Service Bulletin

Bulletin No.: PI0998A

PRELIMINARY INFORMATION

Subject: Accessory Tri-Fold Tonneau Cover Prevents Endgate/Tailgate from Closing

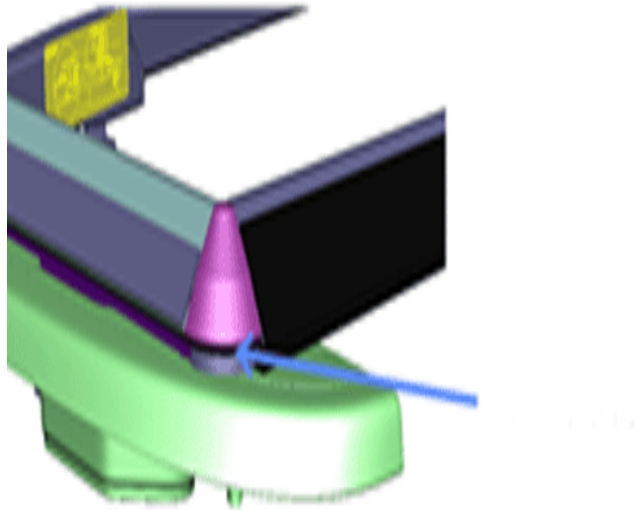
Some customers may comment that the tailgate will not close with the tri-fold tonneau cover in the closed position. This may be due to an early production condition caused by excessive twist in the rear rail of the tonneau cover, and the tailgate molding is not positioned flat on top of the tailgate.

Improve the clearance from the rear rail to tailgate by conducting the following steps below.

1. Open the tonneau cover.
2. Obtain a 50 mm (2.0 in) length of *Kent Automotive Adhesive Back Shim Stock P/N P46515, or equivalent.

3. Cut two pads out of the shim stock, the same shape and size as the two current rear corners pads on the tonneau rail.

4. Attach the shim stock to the current rear corner pads on the right and left side, as shown in the illustration above.

Note: If additional clearance is required, add a second layer of corner pads to each side.
